RESPONSE TO REQUEST FOR ADDITIONAL INFORMATION

APR1400 Design Certification

Docket No. 52-046

RAI No.: 342-8291
SRP Section: 07.08 – Diverse Instrumentation and Control Systems
Application Section: 07.08
Date of RAI Issue: 12/18/2015

Figure: DIS Signal Block Diagram

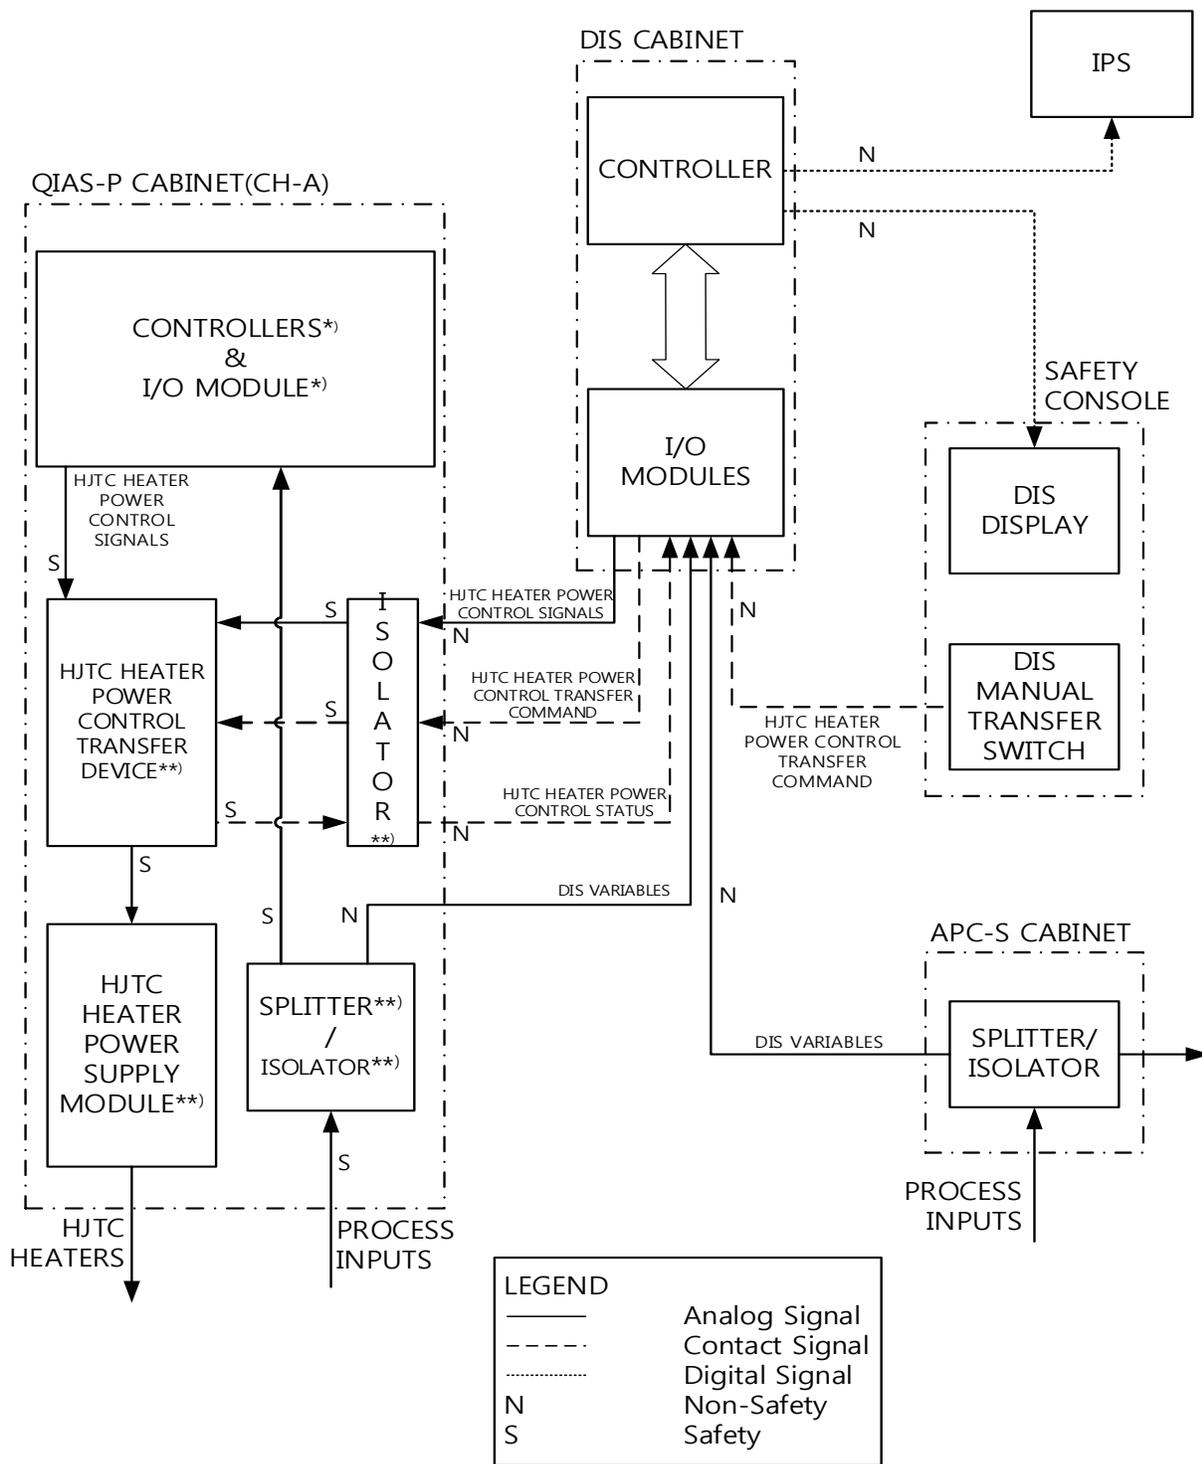
Clarify whether the Diverse Indication System (DIS) manual transfer switch for heated junction thermocouple (HJTC) control is safety or non-safety related and address the potential for a software CCF of the QIAS-P to affect the transfer of HJTC control to the DIS.

Based on the staff's evaluation, **1)** clarify whether the DIS manual transfer switch for HJTC control is safety or non-safety related equipment. **2)** Explain whether a software CCF of the QIAS-P could adversely affect the manual switch or the transfer of HJTC control to the DIS. In other words, could such a failure adversely affect the DIS from performing its diverse functions? **3)** Provide diagram(s) illustrating the interface between QIAS-P and DIS with the manual transfer switch to illustrate such design aspects as safety classification, signal flow and type of signals. **4)** Update the FSAR documents and/or technical reports accordingly.

The 'LIST OF FIGURES' of APR1400-Z-NR-14002 (Rev. 0) will be revised as indicated in Attachment 1. Section 5.2 of APR1400-Z-NR-14002 (Rev. 0) will be revised as indicated in Attachment 2. Figure 5-4 of APR1400-Z-NR-14002 (Rev. 0) will also be newly added as shown in Attachment 3.

the safety I&C systems. The detailed signal interfaces between the DIS and the QIAS-P are shown in Figure 5-4; safety classification, signal flow, and type of signals are also provided in the figure.

Figure 07.08-14-1 Configuration of DMA Switch and DMA Enable Switch

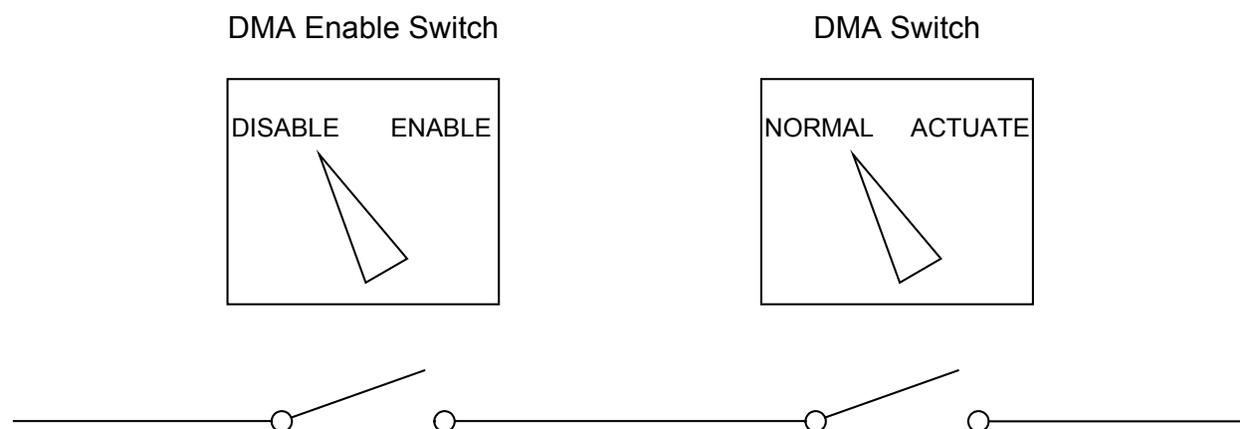
Clarify whether the Diverse Manual ESF [Engineered Safety Features] Action (DMA) enable switch is susceptible to a software CCF the safety system (including the PPS and ESF-CCS) and consequently prevent the DMA switches from performing their diverse functions.

Describe why the DMA enable switch is not susceptible to a software CCF in the safety I&C systems (including the PPS and ESF-CCS) and consequently prevents the DMA switches from performing their diverse functions. In the description, provide analysis and diagrams as necessary to illustrate the independence and the interface between the DMA enable switch and the safety-related I&C systems. In addition, is the DMA enable switch credited for the mitigation of a design bases event which occurs concurrent with a software CCF of the safety system? Update the FSAR documents and/or technical reports accordingly.

The DMA enable switch can block the hardwired signal from the DMA switch to the component interface module (CIM) by using an AND gate function, as shown in APR1400-Z-J-NR-14002-P, "Diversity and Defense-in-Depth", Figure 5-3. The AND gate function is implemented by a simple configuration using conventional hardwired switches, as shown in figure 07.08-14-1.

A DMA enable switch has contacts that are connected to each contact of the DMA switches in series, as shown in figure 07.08-14-1. The DMA enable switch can switch these contacts at the same time to enable the function of DMA switches. The operator needs to turn the DMA enable switch to "Enable" and then turn the DMA switch to "Actuate" to send an actuation signal. These actuation signals of the DMA switches are input to the CIM in the engineered safety features-component control system (ESF-CCS) loop controller (LC) cabinets through an interposing relay for isolation. Therefore, the signals from the DMA enable switch and the DMA switch are isolated from the safety I&C systems.
